**2nd EUROCAE Plugtests™ Interoperability Event
on VoIP for ATM;
Sophia Antipolis, France;
25th March to 3rd April 2009**

Off-air squelch detection with separated Radio Transmitter & Receiver

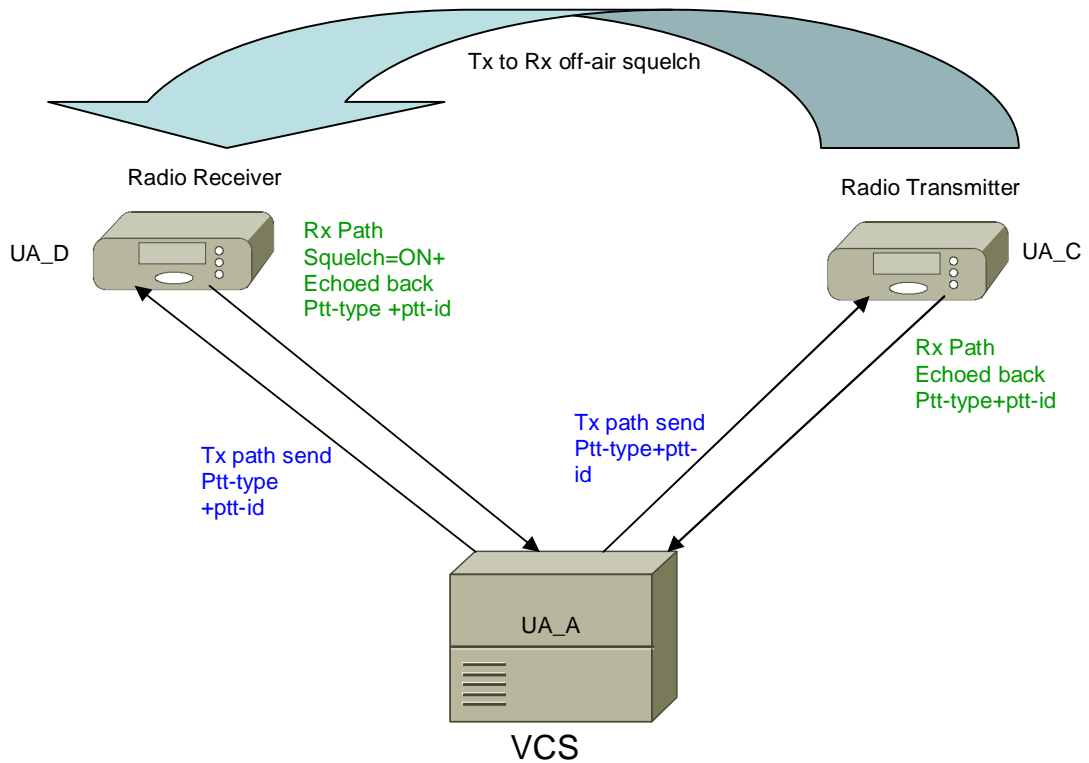
In order to distinguish between a Squelch Signal detected by a Radio Receiver as a result of an Aircraft call and that due to an off-air squelch signal due to PTT activation by a User Agent towards a Radio Transmitter, it is also necessary to inform the Radio Receiver each time PTT is activated towards a Radio Transmitter.

The ED137 Part 1 Radio document should indicate that when PTT is activated by a SIP User Agent this should cause ptt-type and ptt-id to be sent towards the Radio Transmitter, but should also cause the same ptt-type and ptt-id to be sent towards the Radio Receiver.

In this way a Radio Receiver detecting a squelch signal and simultaneously receiving a ptt-type + ptt-id from a User Agent will recognise that the squelch signal is infact off-air squelch.

Off-air squelch detection with Radio Transceiver

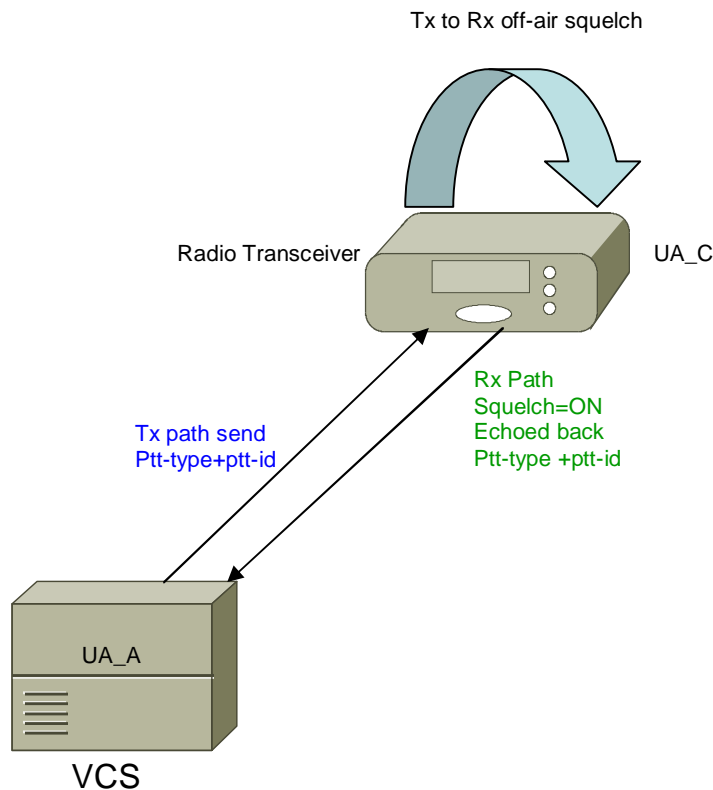
A Radio Transceiver detecting a squelch signal and simultaneously receiving a ptt-type + ptt-id on Tx path from a User Agent will recognise that the squelch signal is in fact off-air squelch. The Squelch, ptt-type + ptt-id will be sent on Rx path back to User Agent. Refer to the diagram below.
